Report: TAB REPORT
Function: Test, Adjust, & Balance
Date: 10/06/2023

09-04-23 PENN STATION - BELLEVUE, NE

Project: 09-04-23 PENN STATION - BELLEVUE, NE

GRD
09/11/2023

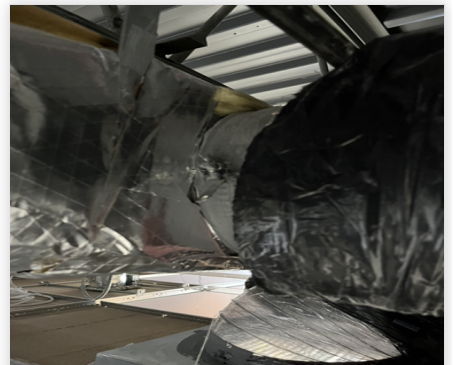
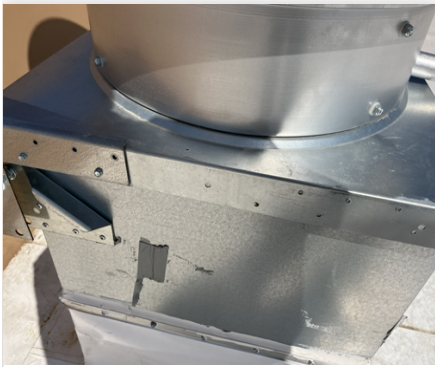
Issue Name : DIFFUSER 2-9 covered in mastic
Description : Damper on diffuser 2-9 on the GRD is shut and covered with mastic and is allowing no airflow through. The damper needs to be free to be locked down at the proper airflow.
Created By : National TAB **Assigned To :** National TAB - Jacob Davidson
Status : Open
Priority : Medium **Asset Tag :**
Originated Date : 09/11/2023 - Jacob Davidson - National TAB
